ADDRESS: 302 MARKET ST

Proposal: Demolish two-story building; construct five-story building

Review Requested: Final Approval

Staff Contact: Alex Till, alexander.till@phila.gov

1 North (Market Street) Elevation
1/4" = 1'-0"

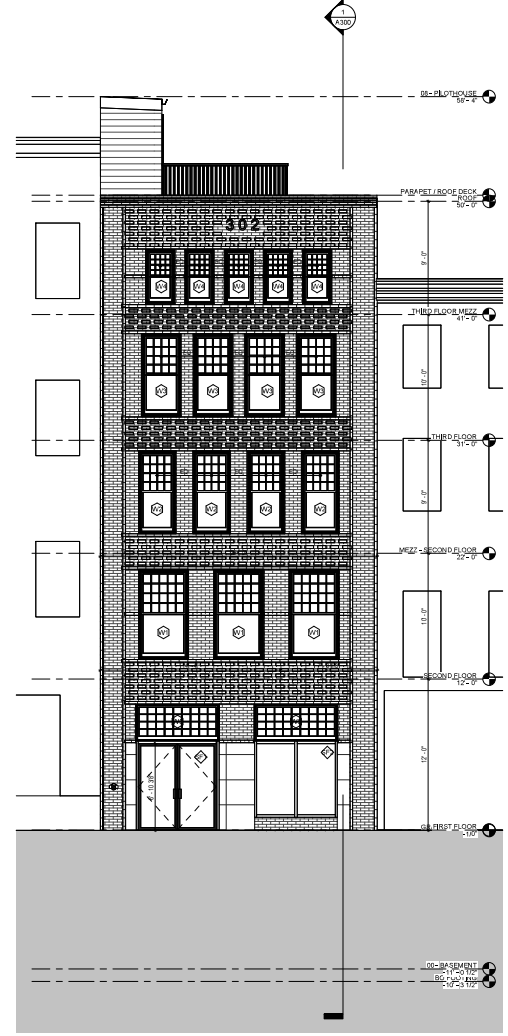
- *Standard 9: New additions, exterior alterations, or related new construction shall not destroy historic materials that characterize the property. The new work shall be differentiated from the old and shall be compatible with the massing, size, scale, and architectural features to protect the historic integrity of the property and its environment.*
 - The proposed new building will satisfy Standard 9 if the proposed windows are revised. The height of the building fits well within the row and the proposed materials and other design elements are compatible with the massing, size, scale, and architectural features of the district.
 - The windows on the upper floors would be fenestrated with windows with multi-light top sash with single-light bottom sash. If they are revised to use the same arrangement on both sash, they will satisfy Standard 9.

STAFF RECOMMENDATION: Approval with the condition that the upper-floor windows are simplified, pursuant to Standard 9.
